Proposed Residential
Development at Howth Road,
Dublin 3

Stage 1 Road Safety Audit

Document Ref: P21-018-RSA-PD-RP-001

3.1 Problem

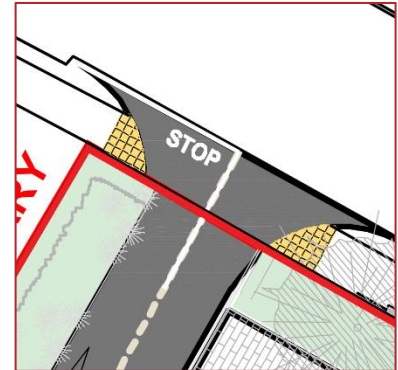
Location: Drawing HOW-BMD-00-ZZ-DR-C1000 (Rev. P4)

Summary: The tactile paving indicated at the uncontrolled crossing of the development access is not of the required depth across the full width of the crossing.

Tactile paving has been indicated on both sides of the access to the proposed development. The depth of the tactile paving, however, is not sufficient across the full width of the crossing for an inline crossing.

This could lead to a visually impaired pedestrian stepping over the tactile paving, where it is of insufficient depth, and inadvertently entering the carriageway without due care and attention where they are at an increased risk of being struck by a vehicle.

Ensure the tactile paving is a minimum of 1.2m deep across the full width of the crossing.

3.2 Problem

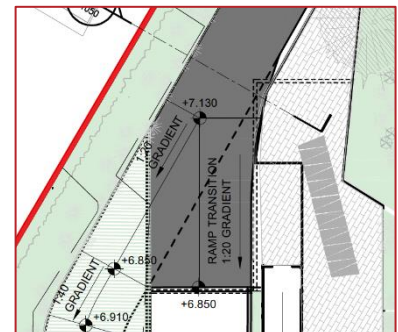
Location: Drawing HOW-BMD-00-ZZ-DR-C1001 (Rev. P4)

Summary: Sudden change in the horizontal alignment of the access and the narrowing of the carriageway at the top of the ramp may lead to poor lane discipline and kerb strikes.

The access road within the proposed development leading to the access ramp to the basement carpark includes sudden changes of direction in the horizontal alignment and appears to widen at the top of the ramp, which coincides with the location of these changes in direction.

A combination of the narrowing cross section and sudden changes in direction may lead to drivers being unable to sufficiently discern the edge of carriageway and thus the narrowing, particularly during the hours of darkness resulting in the potential for kerb strikes and material damage collisions.

Ensure the wider carriageway gradually tapers at the narrowing and that the edge of carriageway is sufficiently visible on the approach to, and departure from, the basement carpark access ramp.

Also, as the design progresses, ensure the access road is sufficiently lit.

3.3 Problem

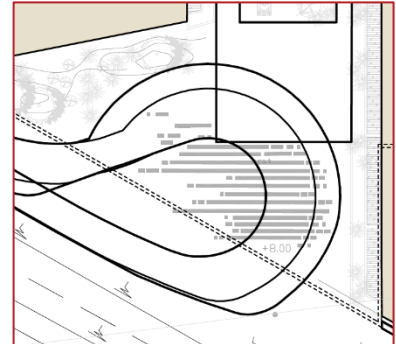
Location: Drawing HOW-BMD-00-ZZ-DR-C1042 (Rev. P4)

Summary: Fire tenders may experience difficulty when travelling in the grassed verge and may reduce the structural integrity of the paved areas within the development.

The swept path for a fire tender within the proposed development is indicated as using the grass verge and pedestrian area when travelling through, and turning within, the development.

It is unclear if the paved vulnerable road user areas will have sufficient structural properties to withstand a fire tender as it undertakes a U-turn manoeuvre. If the pavement is not strong enough to support such loads there is a risk of cracking and structural failure resulting in trip hazards for VRUs.

The 'Grass Pave' area adjacent the top of the basement carpark access ramp should be extended to the rear of the apartment blocks throughout the length of the emergency access route.

Also, ensure the paved VRU areas can sufficiently support the load of a turning fire tender.

3.4 Problem

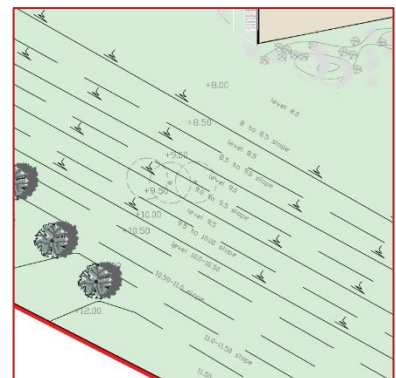
Location: Drawing HOW-BMD-00-ZZ-DR-C1000 (Rev. P4)

Summary: Pedestrians, particularly young children, may climb the embankment to the rear of the development where there is a risk of falls from a height and serious injuries.

An embankment is indicated to the rear of the apartment blocks within the proposed development which is indicated as rising in increments of 0.5m, with level surfaces between each rise, with a total rise of 4m. The Audit Team are concerned that pedestrians, particularly young children, may climb on the embankment where there is a subsequent risk of falls from height and the potential for serious injury.

Measures (i.e. vegetation, landscaping, fencing etc) should be provided at the base of the embankment to deter climbing.

3.5 Problem

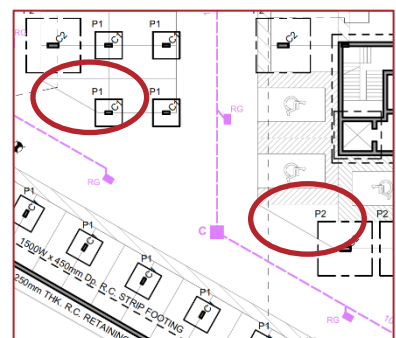
Location: Drawing HOW-BMD-00-ZZ-DR-C1002 (Rev. P4)

Summary: Drivers may park in areas not designated for parking resulting in them encroaching into the traffic lanes.

Triangular areas have been indicated at the end of parking aisles within the basement carpark. The Audit Team is concerned that, should all the spaces in the carpark be occupied, drivers may park their vehicles at these locations where there is insufficient space for a vehicle to park safely outside the carpark carriageway. Should drivers park in these locations, there is a risk of vehicles encroaching into the traffic lane resulting in an increased risk of low speed material damage collisions.

If these areas are for smaller vehicles (i.e. motorcycles), ensure they are sufficiently marked as such. Otherwise, these areas should be hatched

3.6 Problem

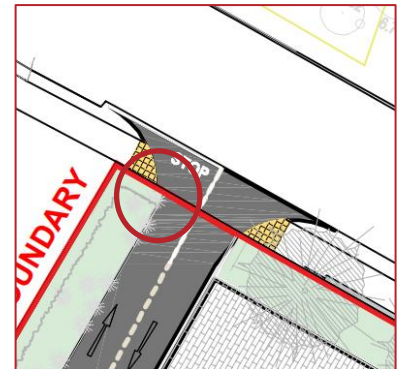
Location: Drawing HOW-BMD-00-ZZ-DR-C1002 (Rev. P4)

Summary: Junction control and priority has not been indicated within the basement carpark.

Junction control and priority has not been indicated at locations where the aisles within the carpark intersect. This could result in driver confusion and hesitation leading to collisions should drivers assume that they have priority over vehicles in adjacent carpark aisles, leading to low speed collisions and material damage.

Junction control and priority should be clearly provided via roadmarkings at locations where aisles intersect within the carpark.

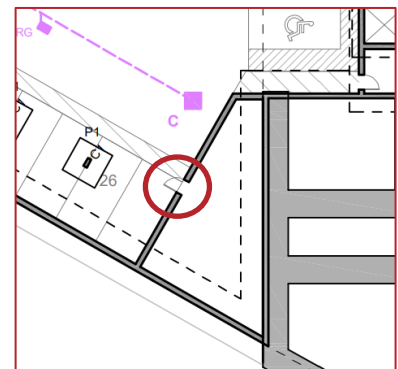
4.2 It is unclear if cycle parking has been provided within the development. No facilities appear to be indicated at ground level. Two large rooms have been indicated within the basement carpark which the Audit Team assume is for this purpose, however, it has not been noted on the drawing as such. A failure to provide formal cycle parking facilities within the development may lead to cyclists parking their bicycles at inappropriate locations which may result in footpaths, or accesses, being blocked.

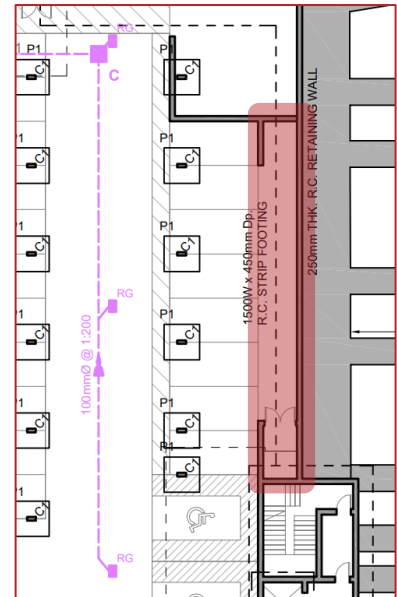
4.3 A room has been indicated in the south-eastern corner of the basement carpark accessed from a door adjacent a parking space. When this space is occupied this door will be blocked restricting access to this room. The door should be relocated, or the parking space removed, to ensure access to this room is possible at all times.

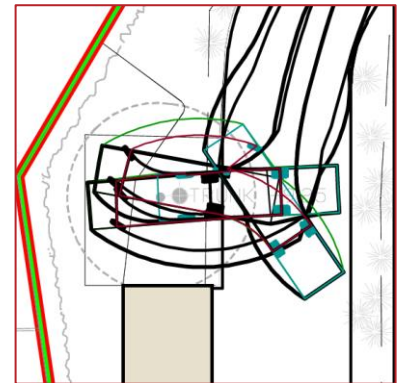
4.4 An access route has been indicated to the rear of the easterly most aisle of parking spaces within the basement carpark. It is unclear where this route leads to as a door has been indicated at one end, and a wall at the other. When the adjacent spaces are occupied access to/from this 'corridor' will be restricted which could lead to pedestrians who enter the carpark at this location being unable to leave this 'corridor.' An exit should be provided to allow safe access/egress at all times.
